RECEIPT DATE: 7/24/23 **ONSITE SEWAGE DISPOSAL SYSTEM** P 574964

PROPERTY ADDRESS: 1872 Woodbine Road

SUBDIVISION: Browning Property LOT: 1 TAX ID: _____

SEPTIC SYSTEM
 INSTALLATION SITE PLAN
 BROWNING PROPERTY
 LOT 1

Subject: OSDS Plan_1872 Woodbine Road

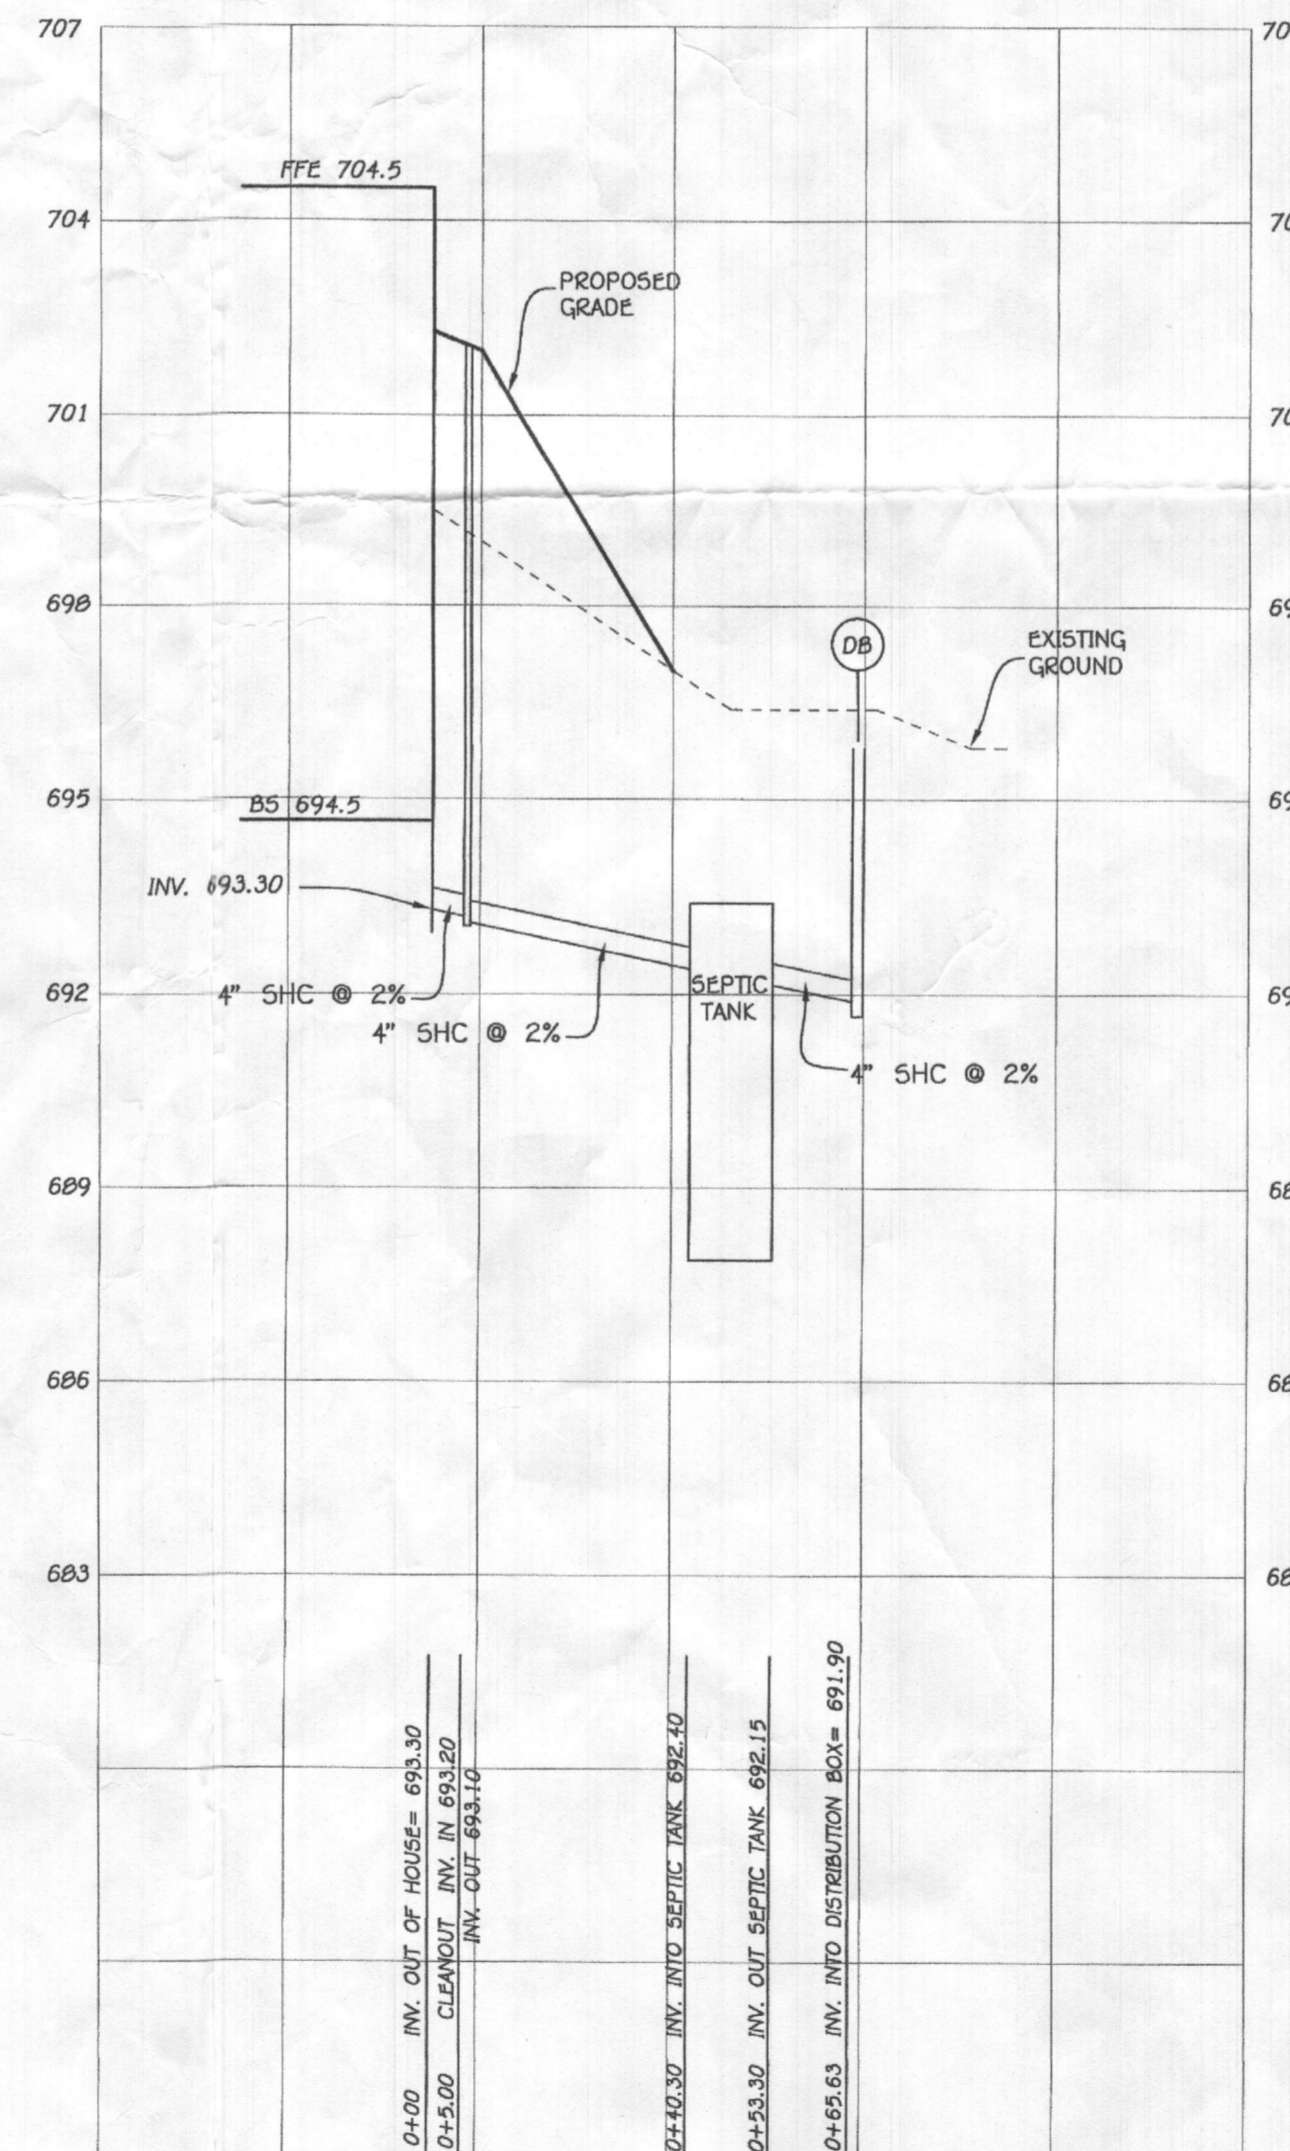
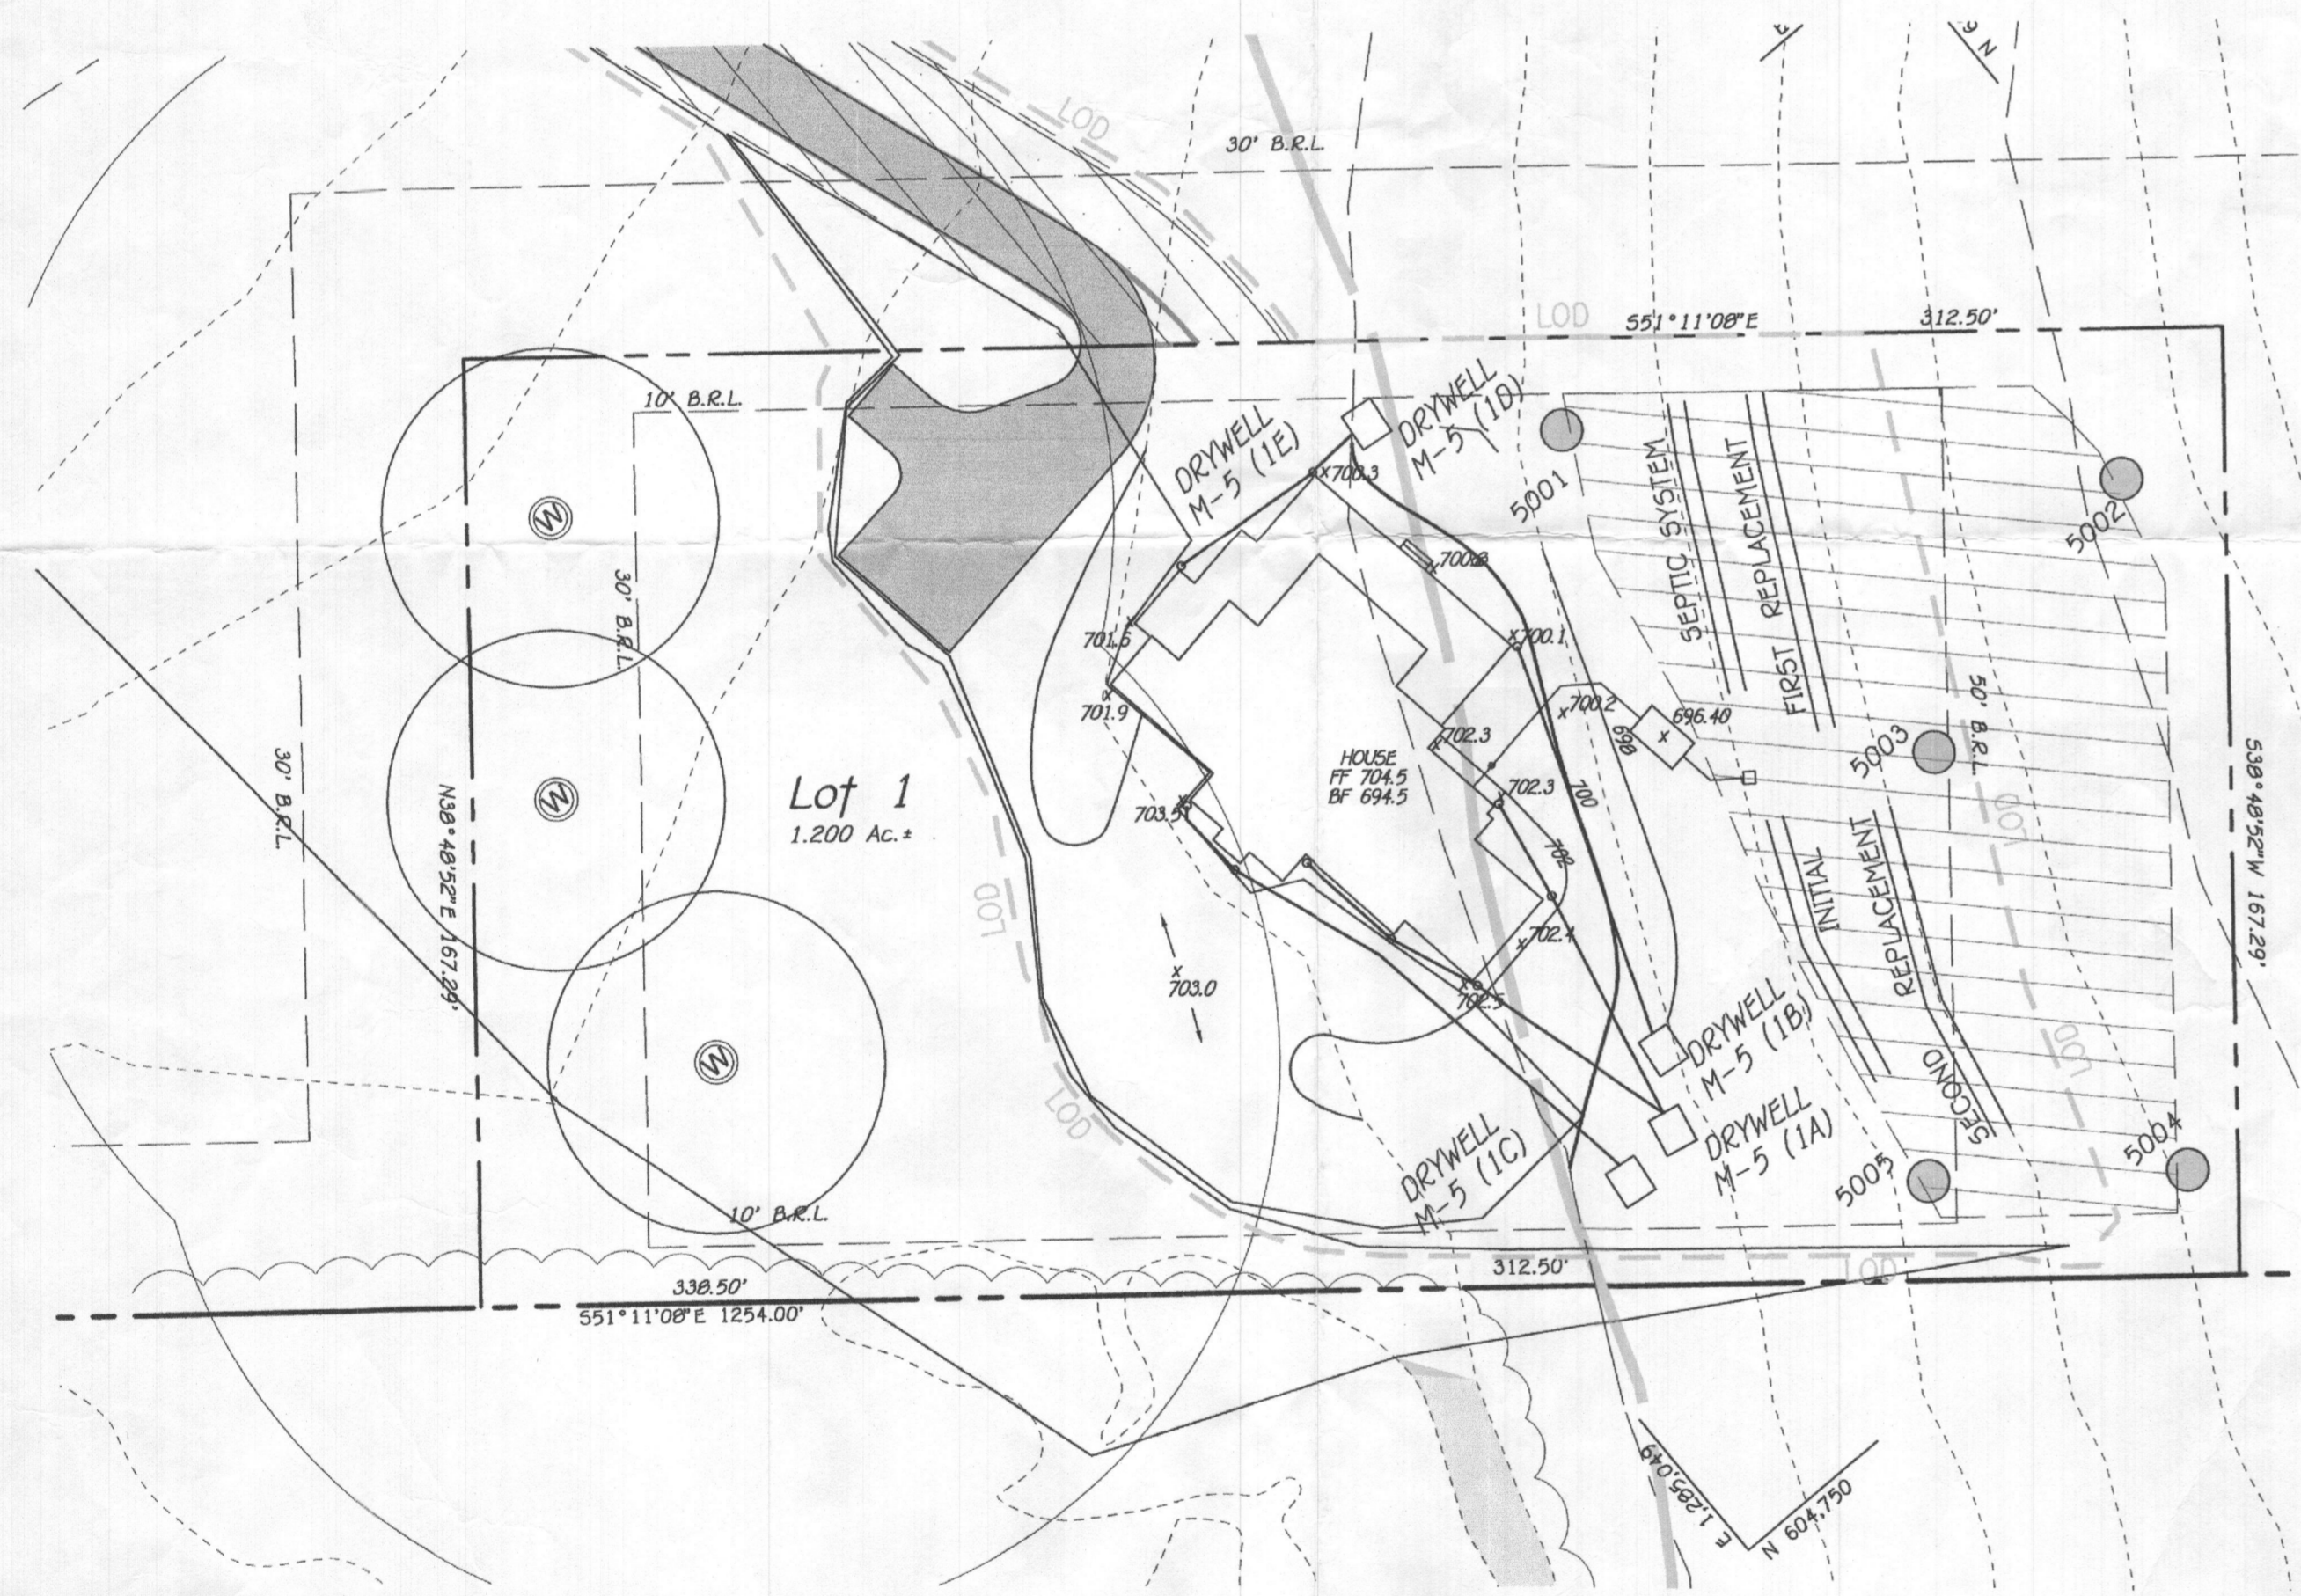
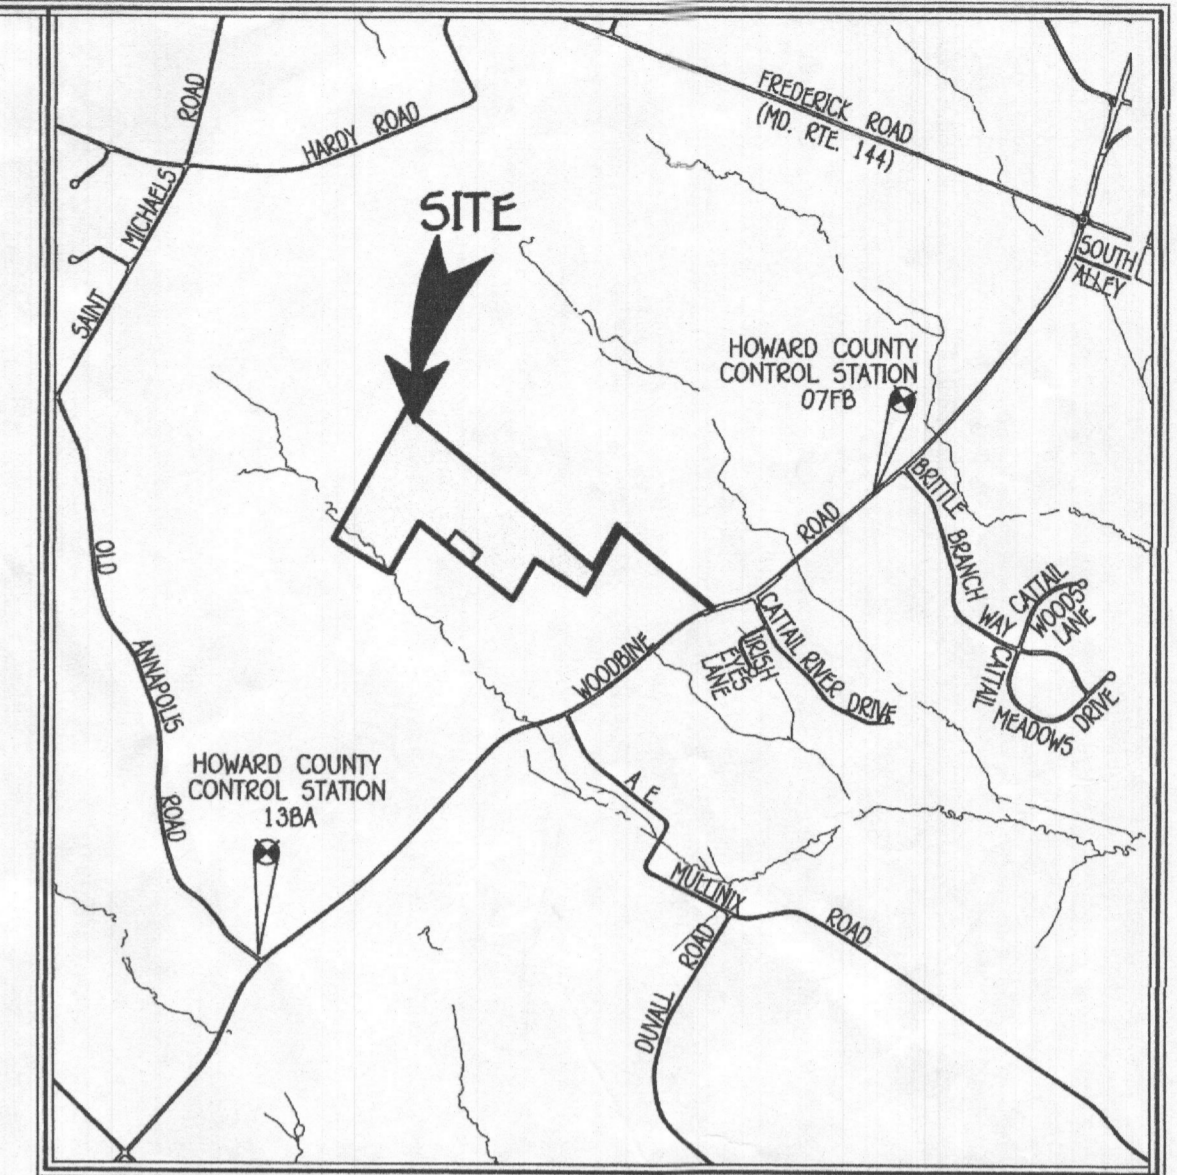
The following comments pertain to the review of the Browning Property Lot 1.

- 1.) Add new address to plan 1872 Woodbine Road. Address was added
- 2.) Relocate drywell (1B). It's within 25 feet of the SDA. Drywell was moved
- 3.) Raise septic tank. Tank is more than 3 feet below grade. Grading was revised for tank depth to be 3'
- 4.) Raise trench invert (if possible) for better use and design of trench. Trench invert is at max depth. Trench depth was set at 4' to allow basement gravity.
- 5.) Ensure trench spacing is being met for all systems. Trench spacing is at 11' for initial system perc spec.
